**Tack Site, Sandyford SHD**

**Stage 1 Storm Water Audit**

**221140-PUNCH-XX-XX-RP-C-0001**

**March 2022**

Job No.	18ASA	Drawn By	NN
Dwg No.	T-L1-500	Checked By	JM
Scale	1 : 250 @A1	Date	MARCH 2022

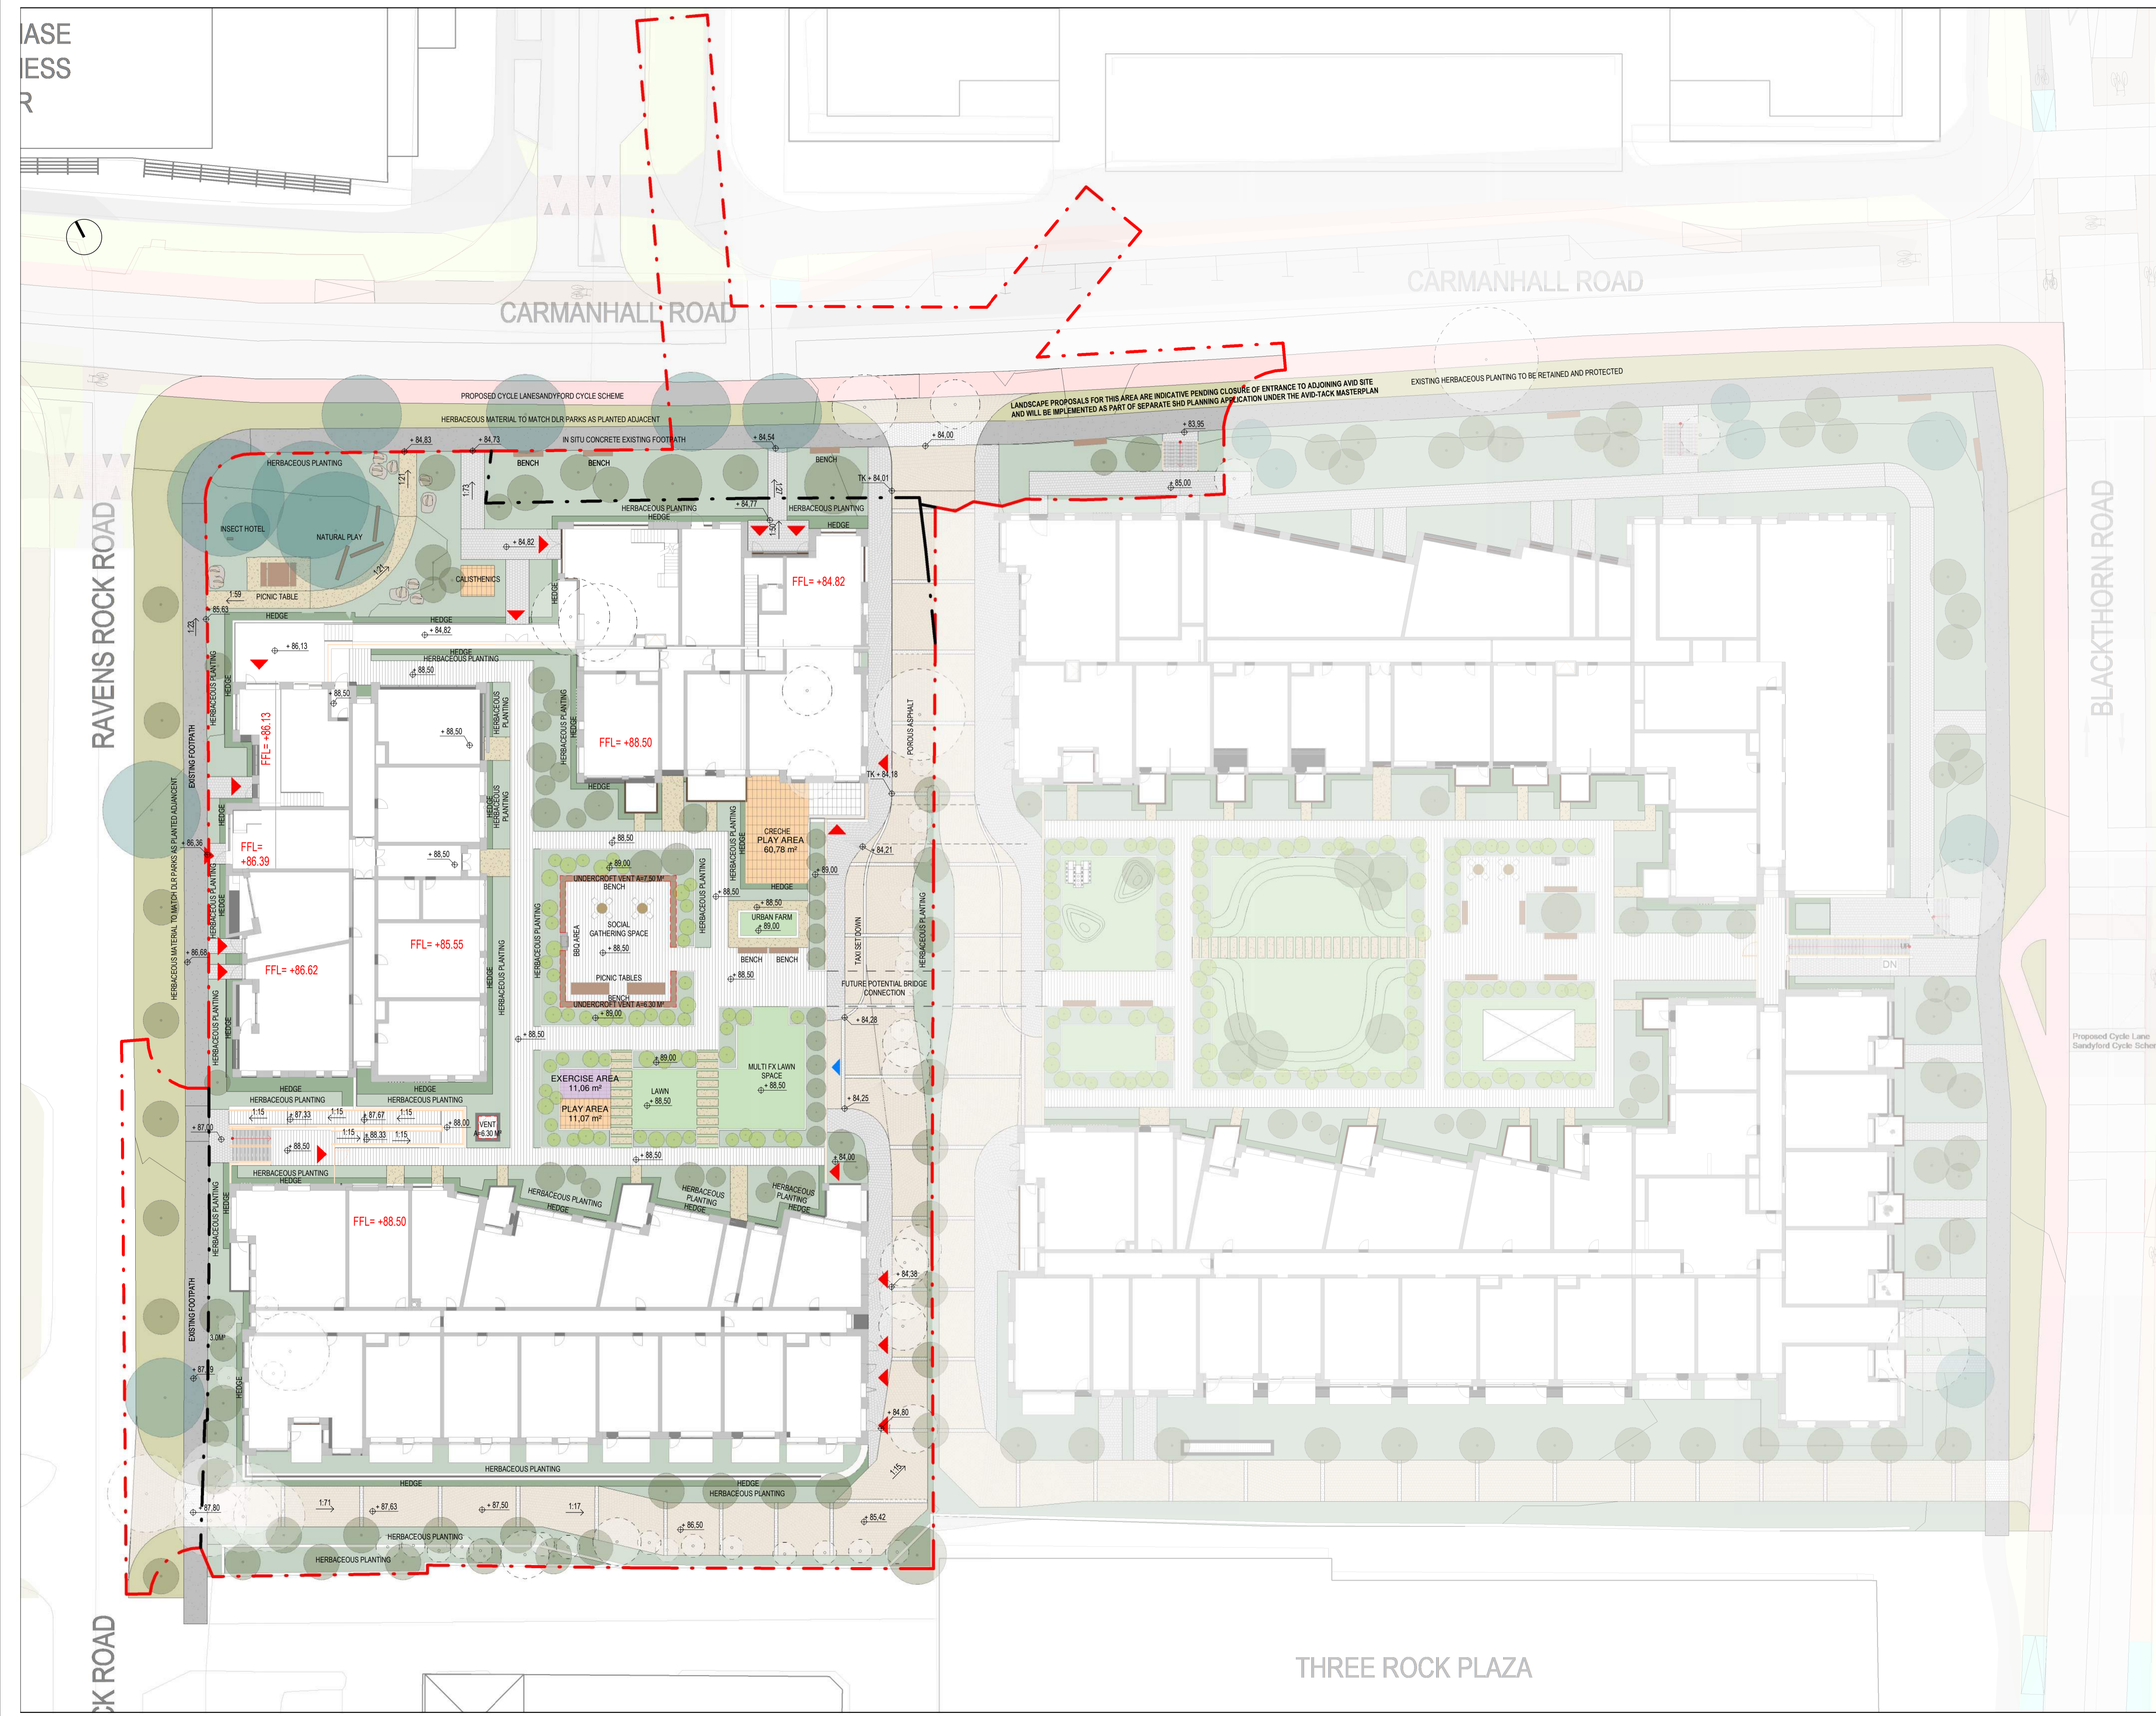
**Problem:** The provided SuDS layouts does not clearly show the surface finishes for all areas within the site boundary.

**Recommendation:** A single drawing should be prepared that shows the surface finishes for all areas within the site including hard/soft landscaping. It should be clear at what level the surfaces are i.e., Ground, podium & roof level. SuDS to be considered which include filter drains, swales, bio-retention systems, tree pit systems, pervious pavements, etc. Details of the SuDS measures to also be provided.

2.1.3	Yes	Yes	Suds finishes are indicated in updated drawing P125. In addition, please find attached with this response landscape drawing T-L1-500 showing final surfaces for the overall development.
